DEVELOPMENT APPLICATION ASSESSMENT REPORT

Application Number:	DA2021/0114			
Responsible Officer:	Julie Edwards			
Land to be developed (Address):	Lot 23 DP 11358, 74 Cumberland Avenue COLLAROY NSW 2097			
Proposed Development:	Alterations and additions to a dwelling house			
Zoning:	Warringah LEP2011 - Land zoned R2 Low Density Residential			
Development Permissible:	Yes			
Existing Use Rights:	No			
Consent Authority:	Northern Beaches Council			
Land and Environment Court Action:	n: No			
Owner:	Campbell Barrett Holmes Cecelia Anne Holmes			
Applicant:	Site Specific Designs			
Application Lodged:	12/02/2021			
Integrated Development:	No			
Designated Development:	No			
State Reporting Category:	Residential - Alterations and additions			
Notified:	22/02/2021 to 08/03/2021			
Advertised:	Not Advertised			
Submissions Received:	1			
Clause 4.6 Variation:	Nil

Figure 3: Amended section plan

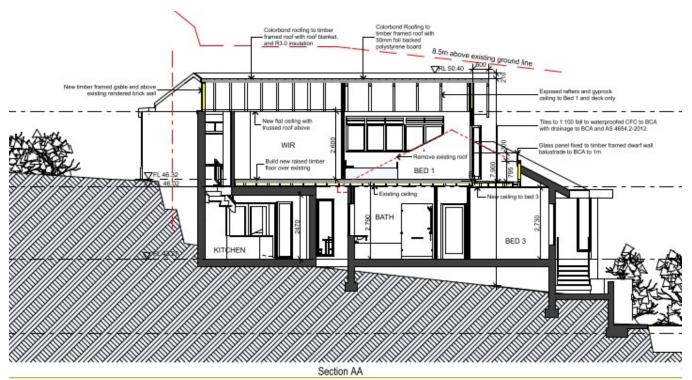
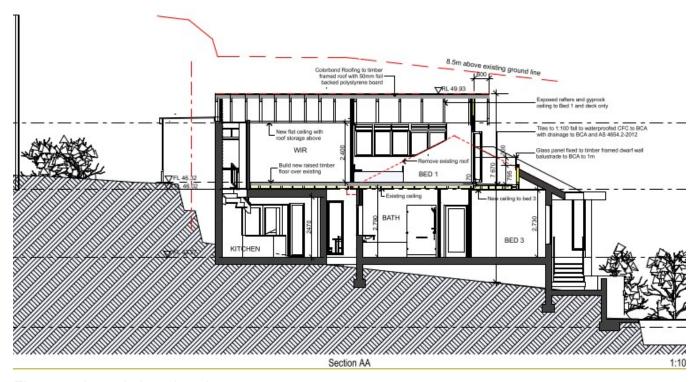
The height poles were erected 12 April 2021 and the height confirmed by a surveyor. A further view loss inspection from of No.7 Lancaster Crescent occurred on the 15 April 2021. After this view loss inspection, discussion where undertaken with the applicant to reduce the height of the first floor addition to improve the views from no. 7 Lancaster Crescent. Amended plans were received, however, the amendments did not go far enough in retaining views from no. 7 Lancaster Crescent and a further request was put to the applicants to reduce the height of the addition. Amended plans and photo montage were received 2 June 2021. The amended plans were forwarded to the occupants of no. 7 Lancaster Crescent for comment. The below view loss assessment is undertaken with the amended plans dated 1 June 2021.

The proposed development has a non-compliance with the rear boundary setback. The non-compliance is existing, however, the proposal includes a change to roof form from flat to pitched within the rear setback. The element of the proposal causing the view impact is the forward eastern end of the upper roof line of the addition. The non-compliance with the rear setback does not create unreasonable view impacts.

Overall, the view impact is regarded as moderate/minor in that the applicant has sought to accommodate the principal views from adjacent properties by reducing the height and pitch of the addition. The proposed first floor addition and alterations to the existing first floor roof have been amended to a more skilful design to retain more of the views from no. 7 Lancaster Crescent.

Amended plans were received which reduced the overall height of the dwelling by 470mm and set the proposed dwelling well below the required 8.5m height requirement as stipulated by WLEP. It is considered that hipped roof designs are not uncommon for the locality and given the compliance with building height and that the proposal would not result in unreasonable view

The proposal has been amended to a more innovative roof profile to retain elements of the beach and water view and address the submissions made in respect of view sharing.

Photo 2: First floor balcony standing with montage

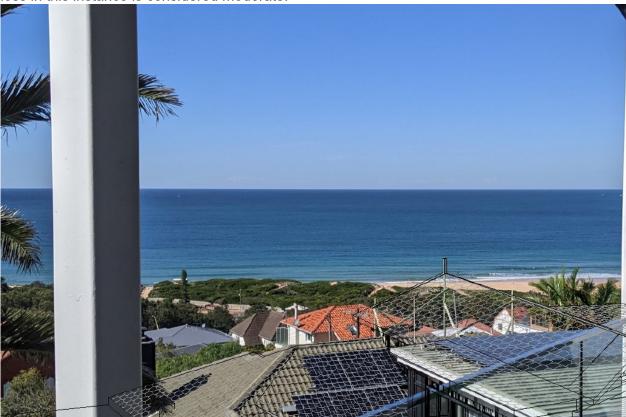
The first floor balcony servicing the dining/living area will lose a portion of Long Reef beach including the interface between land and water in a sitting and standing position. The balcony will retain the majority of the Long Reef Beach, sand dunes and Dee Why Lagoon opening, and views to the southern headlands - Dee why and North Head. The balcony will also retain all views to the north/north-west (photo 3) which include views over Fishermans beach and Collaroy beach, views of Narrabeen Beach and multiple headlands up to the central coast. View loss in this instance is considered moderate.
